AMENDED SCHEDULE OF SUBMISSIONS
PROPOSED STRUCTURE PLAN : Part Lots 11, 74 and 9046L Banjup

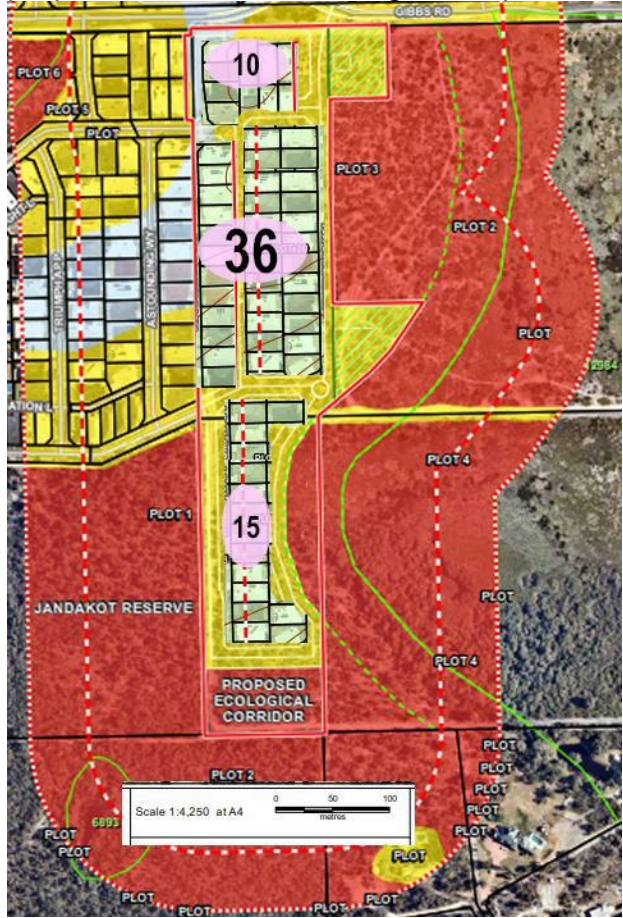
The long finger of development proposed at lot 74 would be surrounded on 3 sides by bushland with little separation from the houses. The Canberra bush fires of 2003 demonstrated how dangerous this can be. Houses had been built on one side of roads and bushland came right up to the other sides. Flames

The bushfire management plan in the structure plan shows that the subject area is surrounded by extreme bushfire hazard level. There could be 60 houses built in the area, as shown in the diagram below, adapted from figure 4 of the proponent's bushfire management plan.

Half of all lots in the subject area would be adjacent to bush land with a Bushfire Attack Level of 29. A separation from the bush land of 15 metres is suggested by the proponent's consultants. Other authorities recommend a separation of 25

metres from BAL 29 bush land. Coincidentally, 15 metres is the 8 metre road reserve and the 7 metre set back of houses from either the front or back fences.

Council might wish to explore in some detail how the consultants derived the 15 metre separation because it is not included in their Bushfire Management Plan.

Instead, the officer recommendation is to remove Lot 74 as a ‘development’ site and cede it as ‘Public Open Space’ (forming a primarily conservation function).

The City agrees that the ‘finger’ of development is inappropriate, and presents an unacceptable level of bush fire risk. For this reason, the officer recommendation is to remove Lot 74 as a ‘development’ site, and therefore no longer have a ‘development finger’ (as originally proposed).

To this end, the officer recommendation is not to support development on Lot 74, instead presenting options for this lot to be ceded as a reserve.
